New South Wales EPA
**Berrima Cement Works
Alternative Fuels**
Submission Review

Issue 2 | 26 February 2016

Job number 245530-00

Figure 3 VOC off-white clinker emissions

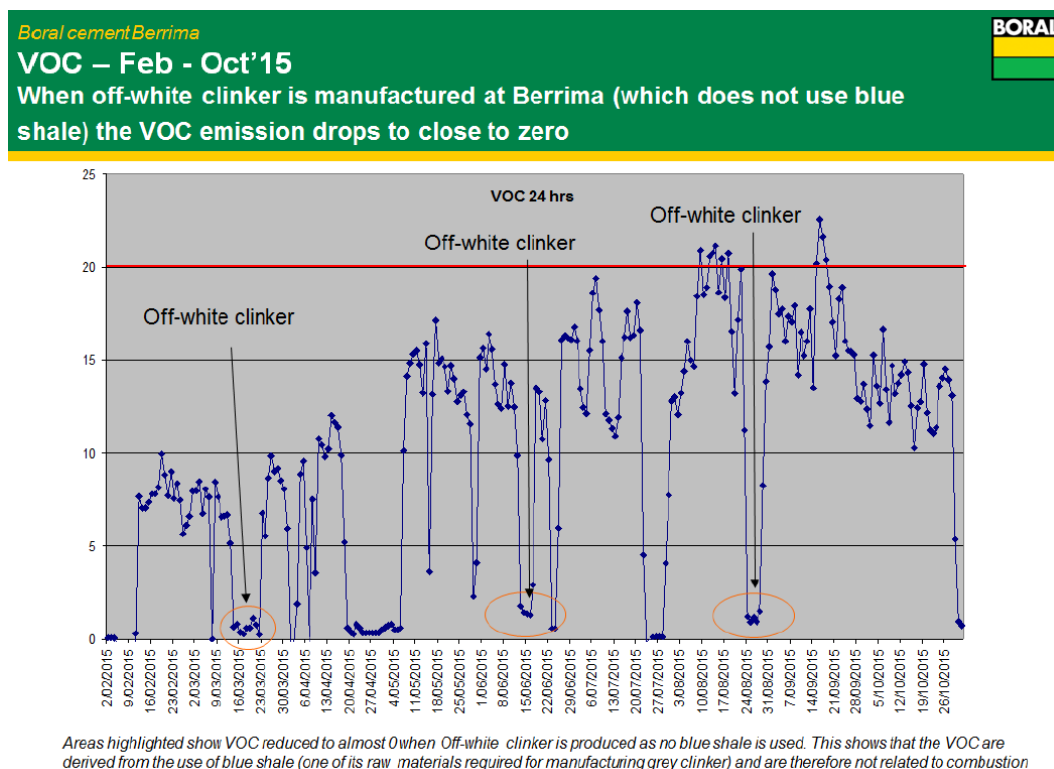
In respect of VOCs, Boral provided information in the EA (Section 4.5.2 and Figure 7) to demonstrate that VOC emissions at Berrima are derived from the use of blue shale (one of the raw materials required for manufacturing grey clinker) and are therefore not related to combustion. Further evidence is shown in Figure 3 which demonstrates that when off-white clinker is manufactured in Kiln 6 (where blue shale is not used) the VOC emission drops down close to zero. The graph also demonstrates that VOC emissions vary over time due to natural variation of blue shale within on-site shale pit resource. At times a 20ppm VOC limit will therefore be exceeded even when not using alternative SWDF. It is therefore physically impossible for Berrima to comply with a continuous VOC limit of 20ppm. It is noted that the NSW Energy from Waste Policy states (in footnote 2 pg. 6) that "an existing facility may apply to the EPA for an alternative NOx and VOCs emission standard in accordance with clause 36 of the Protection of the Environment Operation (Clean Air) Regulation 2010. In view of the above, Boral is proposing to set a practical VOC emission limit of 40ppm, on a 24 hour basis, expressed as non-methane hydrocarbon.

Based on the information provided by Boral we recommend that the 40ppm VOC limit is implemented at Boral.
